*Exhibit No.:*  
*Issue(s):* *Corrections, Evergy MEEIA Report  
and Order, Avoided Costs,  
Reliability and Affordability*  
*Witness:* *J Luebbert*  
*Sponsoring Party:* *MoPSC Staff*  
*Type of Exhibit:* *Surrebuttal Testimony*  
*Case No.:* *EO-2023-0136*  
*Date Testimony Prepared:* *May 30, 2024*

**SURREBUTTAL TESTIMONY**

**UNION ELECTRIC COMPANY,  
d/b/a Ameren Missouri**

**CASE NO. EO-2023-0136**

Figure 1 – Frequency Distribution of Evergy Metro’s NPVRR Across 27 Futures for Selected ARPs

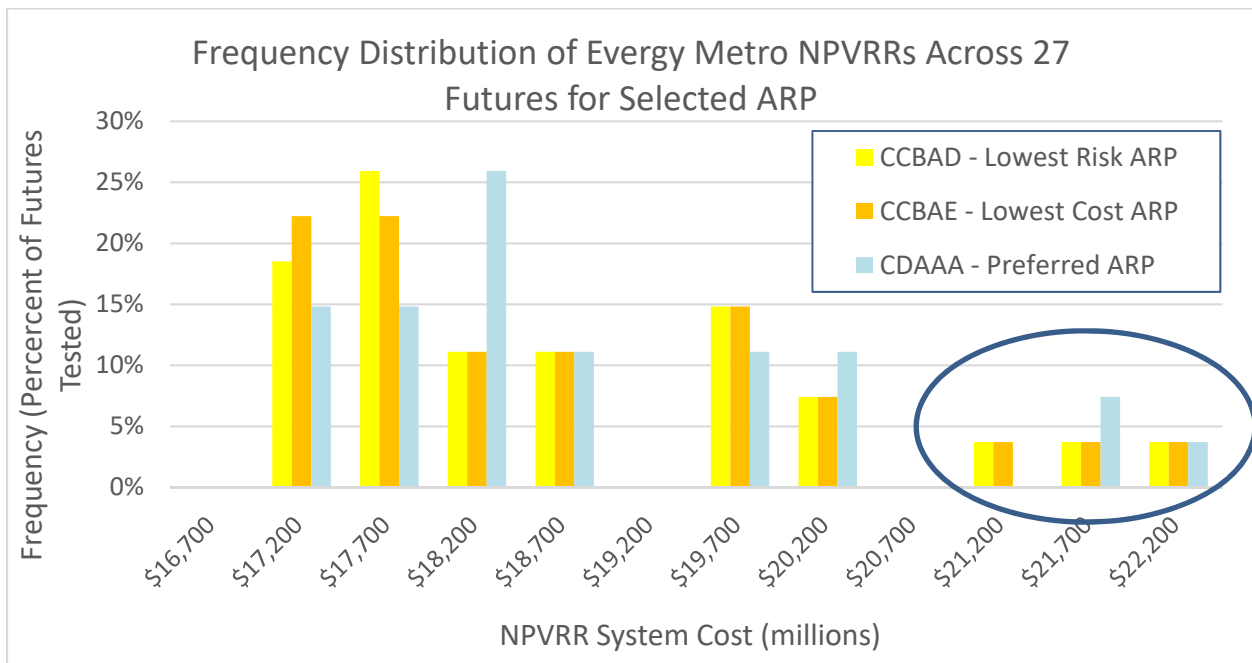
An inspection of Figure 1 shows that Metro’s Preferred Plan (CDAAA) as well as the ARP with the lowest cost (CCBAE) and lowest risk as measured by TailVar90 (CCBAD) exhibit a concentration of NPVRR in the \$17.2 to \$18.7 billion frequency bins. All three ARPs have standard deviations that vary by less than two percent. However, the preferred ARP also exhibits higher frequency of “bad” (i.e., more expensive) outcomes (circled area on graph) than do the two ARPs which have both lower cost and lower risk (as measured by TailVar90). Figure 1 is an example of how using standard deviation as a risk measure may not screen out ARPs with a higher probability of risk.

**Recommendation 2B:** Staff can request that the Company's quantitative risk analysis discuss all of the ARPs it considers in its IRP, and that the Company provide a frequency distribution graph (i.e., histogram) similar to Figure 1 in this memo to show the distribution of NPVRRs across all 27 future conditions.

Figure 2. Relative Cost and Risk of Alternative Resource Plans based on Evergy Metro’s 2022 Annual Update

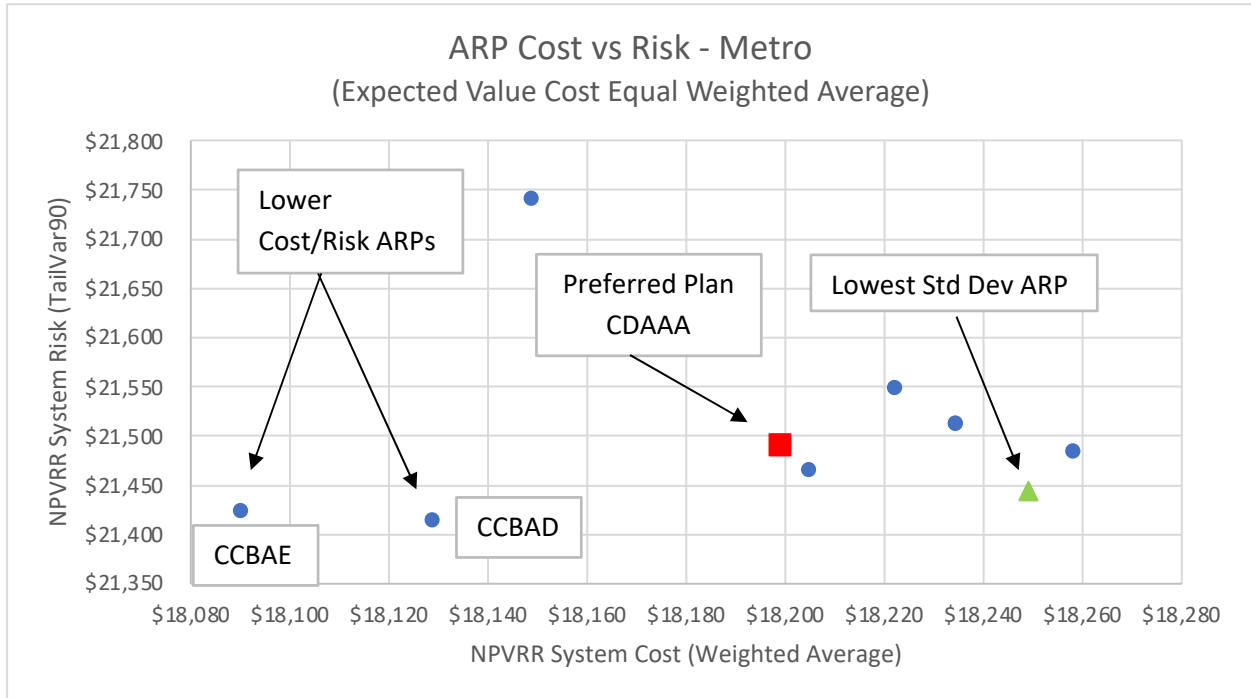
Figure 2 plots the Expected Value NPVRR and TailVar90 for each ARP evaluated by Evergy Metro's system across the 27 of the future conditions shown in Figure 5, page 59 of their update. This graph can be used to compare the relative cost and risk of the 2022 Update ARPs. The TailVAR90 of each ARP is the y-axis (risk) input<sup>3</sup> and the weighted average NPVRR of each ARP across all 27 future conditions is the x-axis (cost) input. Figure 1 allows for the comparison of the expected cost of all resources plan and risk, using a coherent measure of risk. Resource plans that are both lower cost and lower risk will appear nearest the graph's origin, higher risk plans towards the top of the graph and higher cost plans towards the right side of the graph.

A review of Figure 2 shows that the ARP with the lowest Standard Deviation, is neither the lowest cost ARP nor the lowest risk ARP (as measured by TailVar90). Moreover, the Preferred Plan selected by Evergy Metro (CDAAA, shown as the red square) does not appear to be either the lowest cost or lowest risk or the ARP with the smallest standard deviation.

**Recommendation 2C:** Staff can request that the Company provide a more detailed explanation of the how the risk analysis described in Section 6 of their updates was used to inform the selection of their preferred plans. Specifically, staff could ask the Company why they selected standard deviation as their risk metric and, since it appears that the APRs with the lowest standard deviations were not selected as the preferred plan by either Metro or West, what role their risk metric played in the selection of their preferred plans. In addition, staff could ask the Company to describe the basis of the underlying probabilities that they assigned to each critical uncertainty factors (Figure 4, p 58 Energy Metro and Energy West) that were used to create 27 futures used to test the ARPs in Plexos.

Figure 3. Relative Cost and Risk of Alternative Resource Plans based on Energy West’s IRP Update

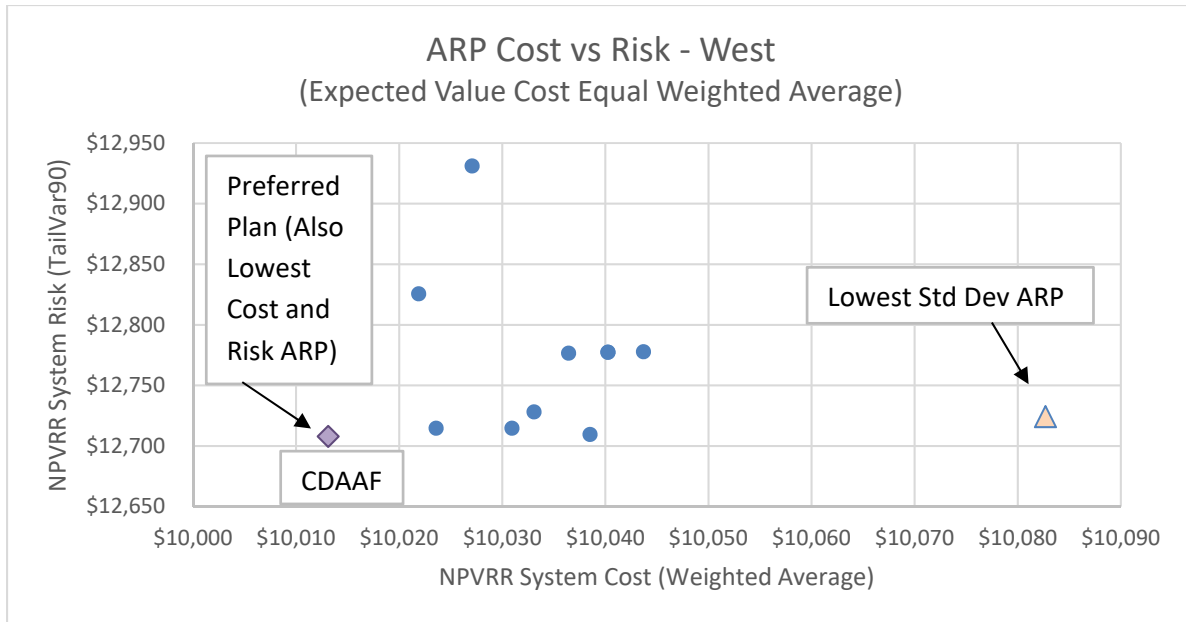
On the other hand, an inspection of Figure 3, which shows the same data as Figure 2, but for Evergy West, reveals that the Preferred ARP (CDAAF) is in fact the lowest cost and lowest risk ARP tested in Plexos. However, as is the case for Evergy Metro, the preferred IRP does not have the lowest standard deviation.
